**GUIDANCE CHANGE NOTICE No.3**

**Part 1 Seagoing Ships**

# **GUIDANCE FOR CODE AND CONVENTION INTERPRETATIONS**

**April 2023**

- d. A single row of nozzles

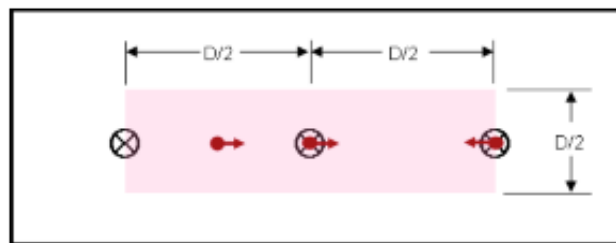
- i) System that extinguishes fires referred to in 3.3.2.3 to 3.3.2.5

For this system, outer nozzles should be placed at least at the edge of the protected area.

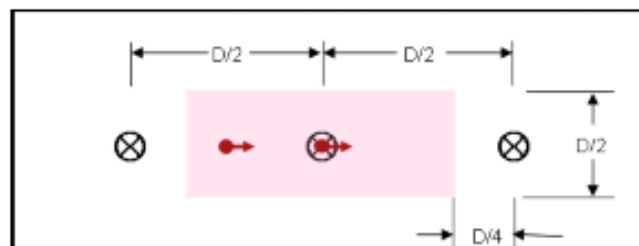
- ii) System that extinguishes fires referred to in 3.3.2.1 to 3.3.2.3

For this system, the outer nozzles should be placed outside of the protected area a distance of at least 1/4 of the maximum nozzle spacing.
